Access Compliance Report

Public Rights-of-Way

(Curb Ramps)

Intersection ID: 3955	Main Street: APPLEVALLEY_CT	Cross Street: ARMITAGE_DR	Location:	N
ADA ID: CB9F90909E68	Ramp Type: BlendTrans1	Initial Pass/Fail: Fail	Overall Compliance: No	Severity Score: 30
Codes/Mitigation Info/Possible Solution		Field Measurements/Component Compliance

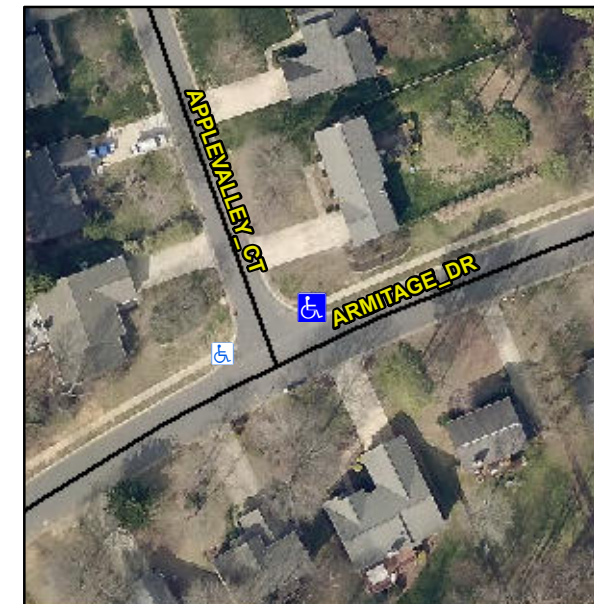
Not Found, R304.5.1, R304.5.3

Compliance	Description	Data	Compliance	Description	Data
N/A	Ramp Length (in)	54.0	Yes	BlendTrans Slope (%)	4.1
No	Ramp Width (in)	34.0	No	BlendTrans XSlope (%)	6.3
N/A	Flare Type LT	N/A	N/A	Flare Type RT	N/A
N/A	Flare Slope LT (%)	N/A	N/A	Flare Slope RT (%)	N/A
N/A	Flare Traversable LT?	N/A	N/A	Flare Traversable RT?	N/A
N/A	Landing Length (in)	N/A	N/A	DWS Provided?	N/A
N/A	Landing Width (in)	N/A	N/A	DWS Contrast?	N/A
N/A	Landing Slope (%)	N/A	N/A	DWS Length (in)	N/A
N/A	Landing X Slope (%)	N/A	N/A	DWS Full Width?	N/A
N/A	Landing Curb? (Y/N)	N/A	N/A	DWS Offset (in)	N/A
N/A	Shared Landing?	N/A			
N/A	Gutter Ponding?	N/A	N/A	Gutter Slope (%)	N/A
N/A	Gutter Lip Ht (in)	N/A	N/A	Gutter X Slope (%)	N/A
N/A	Painted X Walk1?	No	N/A	Painted X Walk2?	N/A
	X Walk 1 Direction	To SW		X Walk 2 Direction	N/A
	X Walk 1 Width (in)	N/A		X Walk 2 Width (in)	N/A
	X Walk 1 Slope (%)	2.2		X Walk 2 Slope (%)	N/A
	X Walk 1 X Slope (%)	4.7		X Walk 2 X Slope (%)	N/A

N/A	Ramp inside XWalk1?	N/A	N/A	Ramp inside XWalk2?	N/A
	Road Slope (%)	4.7		Clear Space?	N/A
	Road X Slope (%)	2.2	N/A	Clear Space to XWalk (in)	N/A
N/A	Any Obstructions?	N/A	N/A	Storm Grate/Utility Hazard?	N/A
	Obstruction Type			Storm Grate/Utility Type	
		N/A			N/A
			Yes	Surface Condition? (G/P)	Good
			No	Curb Slope (%)	15.4

Remove & Replace Curb Ramp With Two New Directional Ramps or Equivalent.
